**ARCHITECTURAL ADDENDUM  
ADD #1**

Re: **Hilliard Township Office Addition  
951678 Hwy 569  
Hilliardton, ON P0J 1P0**

Project No. **22013**

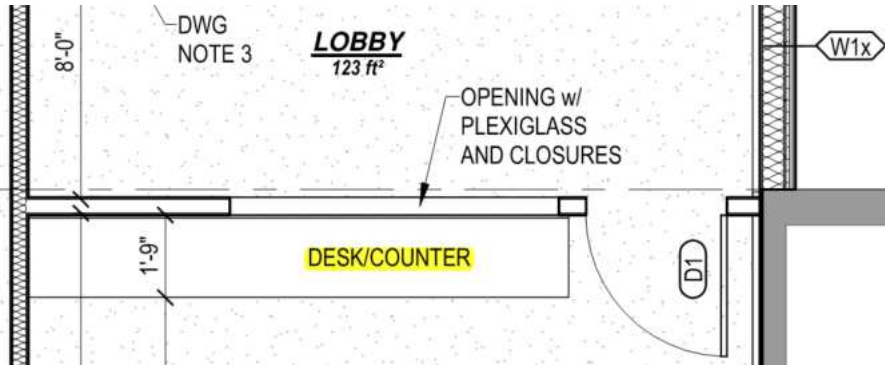
DESK/COUNTER highlighted below

shall measure 11'-6" long and incorporate base cabinets.

for bidding purposes, the counter top shall be: LAMINATE  
with the cash allowance of: 25.00 \$/lin. ft

and the base cabinets shall be: WHITE MELAMINE  
with the cash allowance of: 275.00 \$/lin. ft

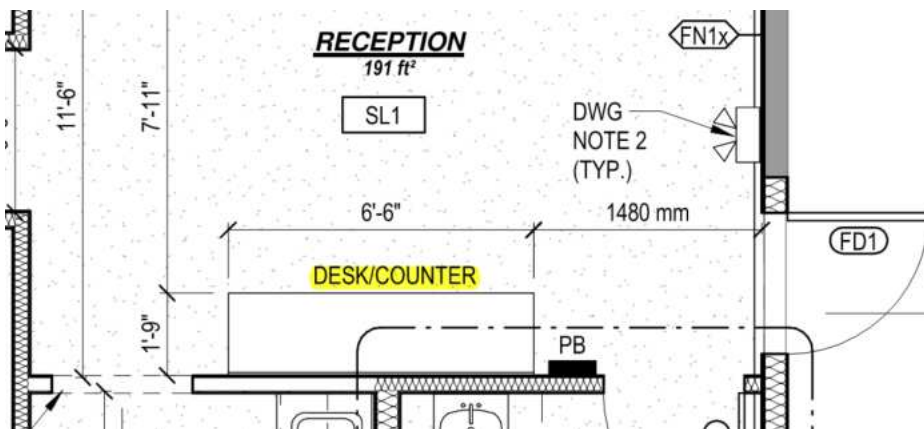
DESK/COUNTER highlighted below

shall incorporate base cabinets.

for bidding purposes, the counter top shall be: LAMINATE  
with the cash allowance of: 25.00 \$/lin. ft

and the base cabinets shall be: WHITE MELAMINE  
with the cash allowance of: 275.00 \$/lin. ft

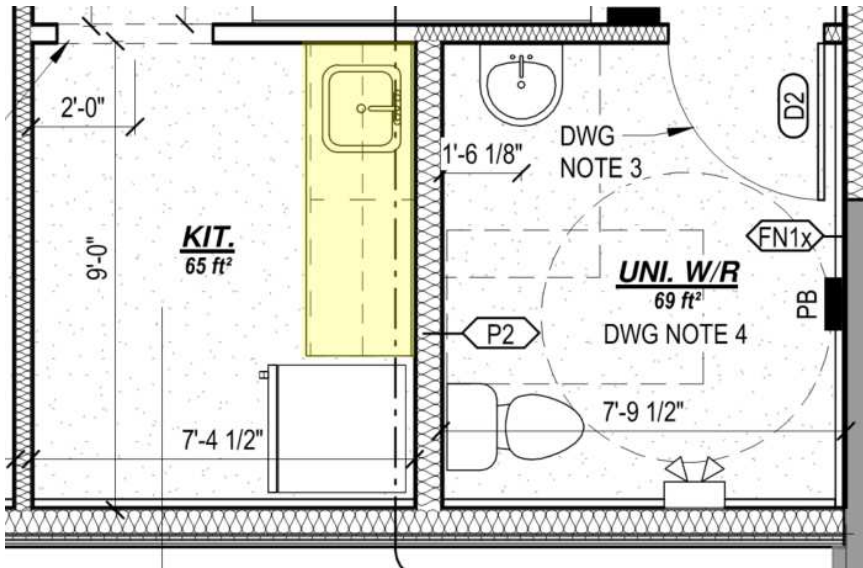
KITCHENETTE highlighted below

shall measure 6'-0" long and incorporate base cabinets.

for bidding purposes, the counter top shall be: LAMINATE  
with the cash allowance of: 25.00 \$/lin. ft

and the base cabinets shall be: WHITE MELAMINE  
with the cash allowance of: 275.00 \$/lin. ft
